Clocks 0.1-review - top assembly

75 x 70 mm / scale 1:1 / viewed from above

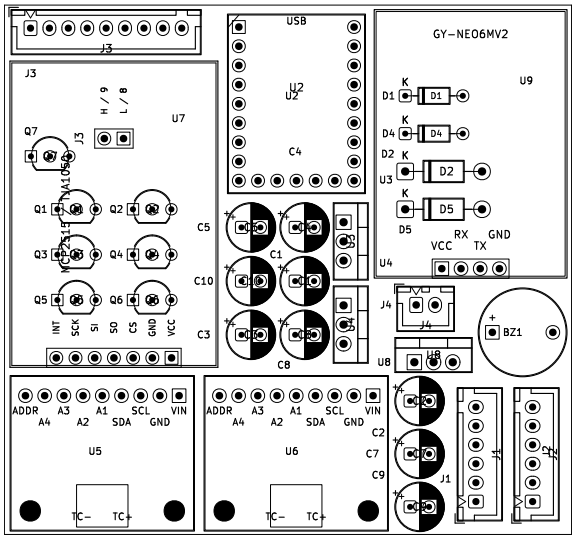
CAN / GPS underside: 12 mm above carrier (proposed).

Parts under these modules: maximum installed height 8 mm.

Check actual module undersides, supports and cable access.

MCP9600 holes support modules; enclosure mounts are not defined.

Review placement and cooling before ordering a prototype.
